APPROVAL FOR CONSTRUCTION

APPROVAL # 134827

TOWN/CITY LOCATION: Seabrook
STREET LOCATION: Ledge Rd.

PLAN OF PROPOSED SEPTIC SYSTEM

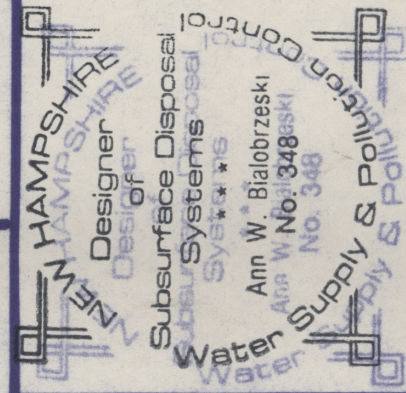
NOTE: (X) Gravity system () Gravity system to septic tank and effluent pump chamber with disposal system to be constructed on a properly prepared base.

(X) no less than 32 " above the original grade

to maintain (X) 4 ' minimum above (the reported) (any) seasonal high water table.

(X) Fill to prepare disposal area should be a medium to coarse sand (0.5 to 1.0 mm).

CONDITIONS: Foundation drains are not permitted. Installation of foundation drains shall void this approval.

ADVISE YOUR CONTRACTOR OF REQUIRED CHANGES IN PLANS AS INDICATED ON THIS CONDITIONAL APPROVAL.
